Access Compliance Report Public Rights-of-Way (RR Crossings)

Intersection ID: 53713	Main Street: N_TRYON_ST	Location: N/A
ADA ID: 9A22FAAEF4C7	Overall Compliance: No	Severity Score: 0.0
Codes/Mitigation Info/Possible Solution		Field Measurements/Component Compliance

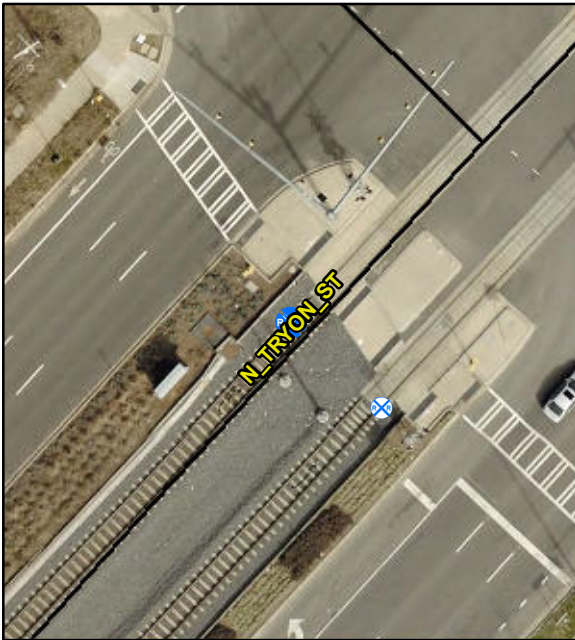
Remove & Replace Detectable Warning System. Provide Pedestrian Gate. Remove & Replace Walking Surface Adjacent to Rail.

Compliance	Description	Data
Yes	DWS Provided?	Yes
Yes	DWS Contrast?	Yes
Yes	DWS Width (in)	Yes
Yes	DWS Length (in)	24.0
No	DWS Offset (in)	66.0
No	Pedestrian Gate?	No
N/A	DWS Outside Gate?	No
N/A	Rail Type?	LightRail
No	Flangeway Gap (in)	2.5
Yes	Sidewalk Width (in)	142.0
